**Docket Item # 6**

**Development Special Use Permit #2016-0012**

**2360 Eisenhower Avenue & 2300 Dock Lane - EESAP Blocks 11 & 12 Extension**

<b>Purpose of Application</b>
Approval of a three-year extension for a previously approved Development Special Use Permit, DSUP #2013-0008 for two blocks in the <i>Eisenhower East Small Area Plan</i> area.

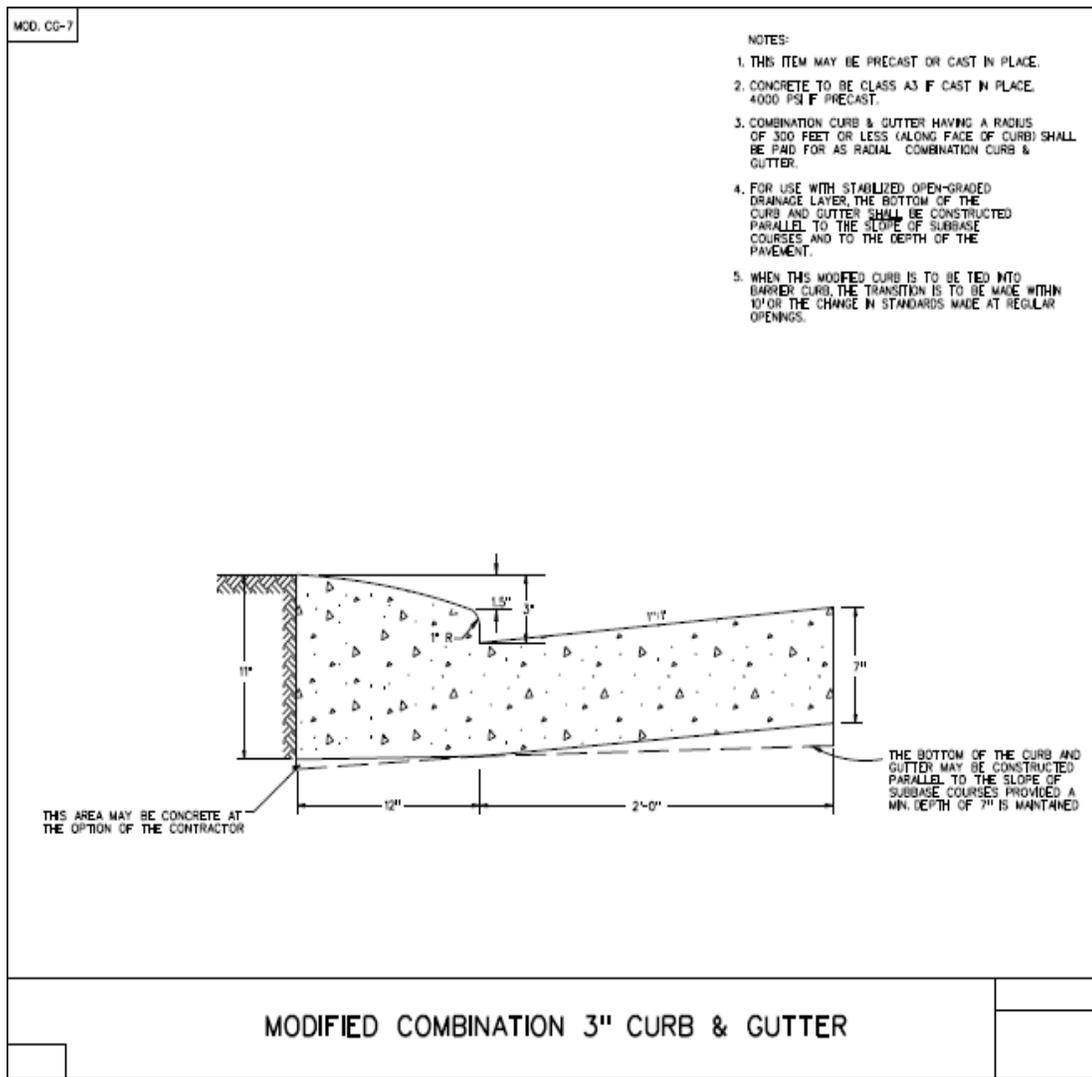
- C - 8** The fire service plan shall show placement of emergency vehicle easement signs. See sign detail and placement requirements are as follows:

Emergency vehicle easements shall be a minimum of 22 feet across the travel lane. The emergency vehicle easement shall provide access to strategic areas of the building and fire protection systems. Curbing and street components shall conform to the standards established by Transportation and Environmental Services and this document for emergency vehicle easements.

Emergency vehicle easement signs shall be metal construction, 12-inches wide and 18 inches in height. Provide red letters on reflective white background with a 3/8-inch red trim strip around the entire outer edge of the sign. The lettering shall say "NO PARKING," "FIRE LANE," "EM. VEH. EAS.," and "City of Alex.," Lettering size shall be as follows: "NO PARKING" - 2 inches, "FIRE LANE" - 2½ inches. EM. VEH. EAS. - 1 inch, CITY OF ALEX. - ½ inch. Directional Arrows - 1 inch by 6 inches solid shaft with solid head - 1½ inches wide and 2 inches deep (For examples, see Figures D102.1, D102.2, and D102.3). Signs shall be mounted with the bottom of the sign 7 feet above the roadway, and shall be properly attached to a signpost or other approved structure such as designated by the fire official. Posts for signs, when required, shall be metal and securely mounted. Signs shall be parallel to the direction of vehicle travel and posted so the directional arrows clearly show the boundaries and limits of the Emergency Vehicle Easement. In areas where emergency vehicle easements involve two-way traffic, double mounted signs shall be provided. The maximum distance between signs shall be 100 feet. Other special signs or modifications to emergency vehicle easement signs shall be approved by the fire official.

*Illustrative F: Staff Alternate Ground Floor Plan - Expanded Retail Space shown in blue*  
 Note that retail elevator location gives direct access to Eisenhower Avenue and lease space.

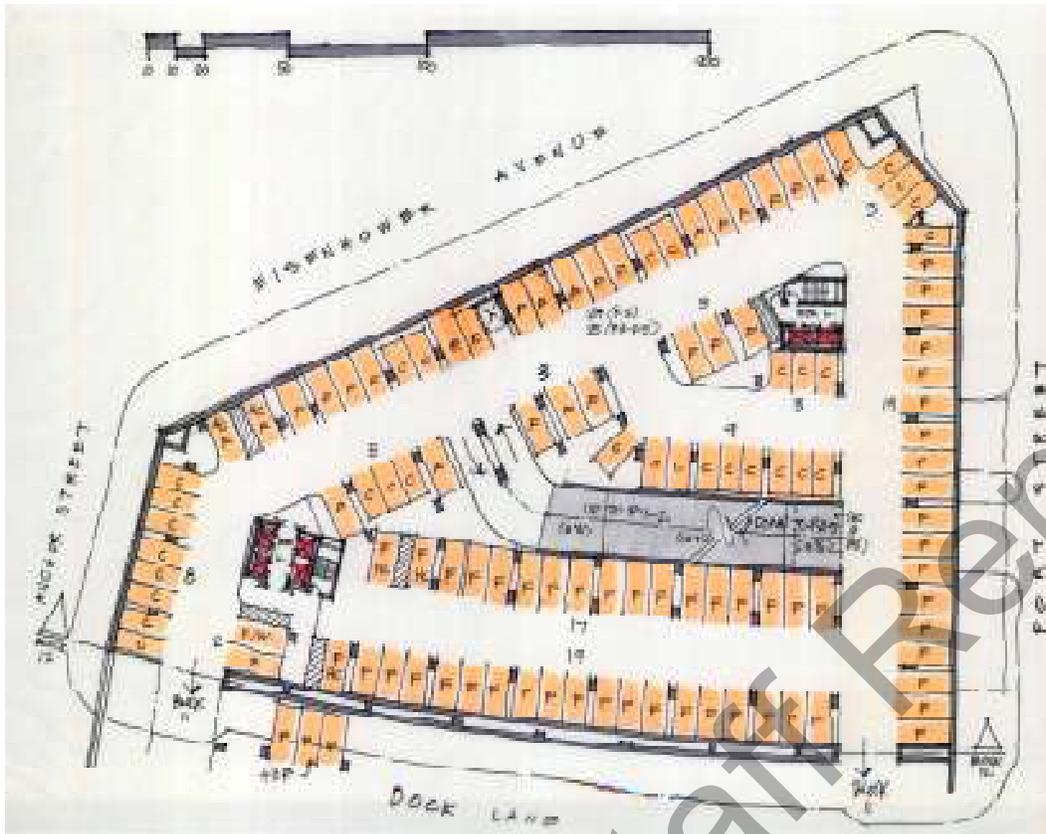
Staff has also consistently noted great inefficiency in the one on-grade and two above-grade sections of garage that have been shown for combined retail and residential parking on Block 12. Using the applicant’s own area calculations, these three, very small and irregularly shaped garage plates park a total of only 96 cars in 68,000 SF. This means that each parking space in this garage takes up more than 700 square feet, compared to an industry standard of around 350 SF/car. Staff has studied an alternate design (see illustrations, below), which considers the redesign of entry, aisle and circulation geometry in the five levels of garage *below Block 12 only*. Staff studies showed that the increased efficiency could accommodate all of the cars currently shown parked above-grade on Block 12 *and* allow removal of all 68,000 SF of above-grade garage (a building area comparable to *two* Charles Houston Recreation Centers.) This design change would also consolidate all of the retail parking for Block 12 on a single level, with a simple one story elevator connection to grade and the retail space along Eisenhower Avenue. It permits the creation of more than a third of an acre of high-quality, south-facing public open space on Dock Lane, (comparable in size to Hunter-Miller Park,) while still saving the applicant a substantial amount of construction cost. This park could include high-quality outdoor dining

opportunities for future restaurants in Block 12, and is also large enough to accommodate retail kiosks, such as the ones found in Bryant Park and elsewhere in Manhattan. The plan changes also allow for greater retail depth (an industry-standard 70-80 feet, versus the 50 feet shown in the current proposal,) and the elevator location – close to Eisenhower Avenue - allows for complete flexibility in retail tenant sizes (versus the current proposal, which requires a passageway at some point, cutting the retail space in half.) This consolidated retail space gains substantial exposure as well, since it would also be visible *and* accessible from the newly-created open space, and its single parking entrance on Port Street is immediately visible to anyone coming to the retail, whether from Southern Street, Dock Lane or Eisenhower Avenue eastbound or westbound. Replacing the two ramps on Dock Lane with a single entry on Port Street also adds a significant number of on-street parallel parking spaces on Dock Lane (from 11 to 17.) Elimination of the above-grade parking structure also allows increased efficiency by relocating tenant and leasing office spaces currently shown on a single-loaded corridor on the second floor facing Port Street to the main building corridor, along with a net gain of 3 – 4 additional dwelling units, and elimination of an exit stair necessitated by the long dead-end corridor in the current proposal. Finally, removal of three levels of mechanically-ventilated garage would save total construction costs in the neighborhood of \$4 million. While these changes would involve some minor adjustments to column and core locations in Block 12, it should be noted that this piece of the project has been identified by the Applicant as Phase II, and there is therefore ample time to make these design changes without impacting the construction schedule for the overall project.

*Illustrative I: Staff Alternate 2<sup>nd</sup> Floor Plan – Replaces Single-Loaded Condition with Double-Loaded*

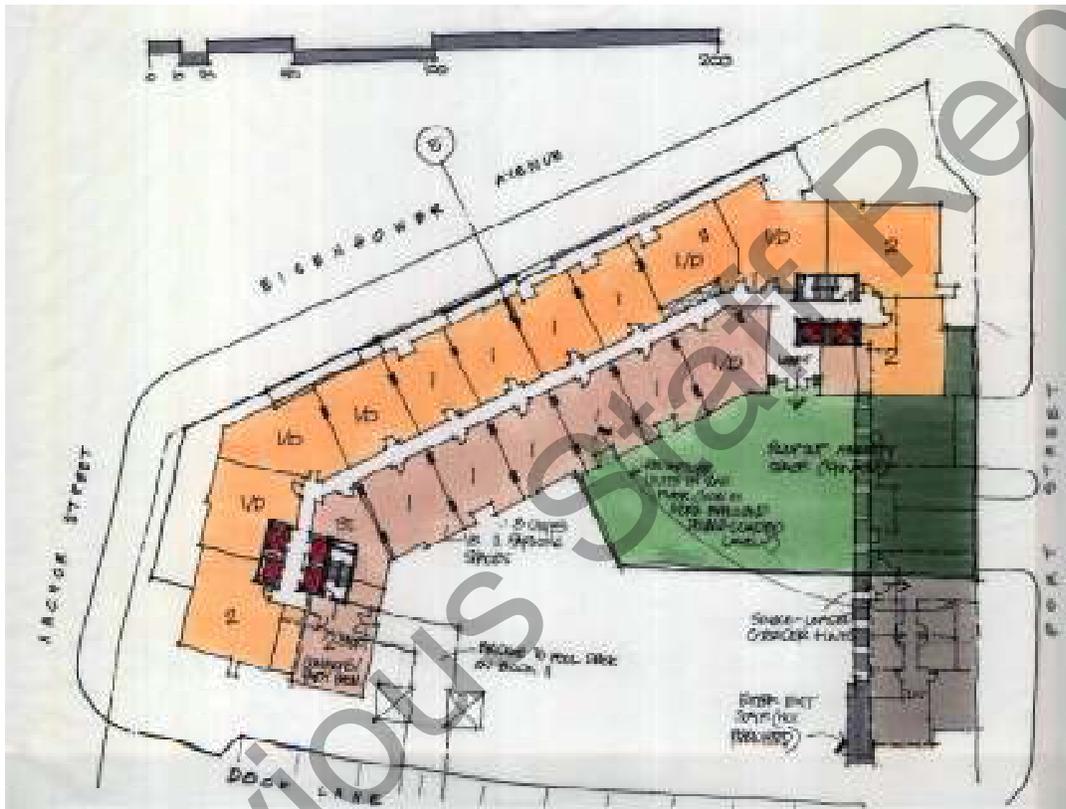
\*) Applicant proposes a total of 95 cars on three above-grade levels - totaling approximately 65,000 square feet, which translates into \$3.5 to 5 million of construction. In

addition, this parking is very inefficient (over 750 square feet per car, versus a standard of around 350 square feet each.) The area freed up by elimination of the above-grade parking can provide over one-third of an acre of ground-level open space. The area on the 2<sup>nd</sup> floor formerly occupied by garage can then be used for additional residential units (yielding several additional units, and eliminating a redundant exit stair and long single-loaded corridor.)

\*\*) Applicant proposes 53 retail spaces on two separate, small levels, which makes searching for a parking space difficult; staff proposal provides 54 retail spaces on a single level, with one-stop elevator connection to retail shops and Eisenhower Avenue.
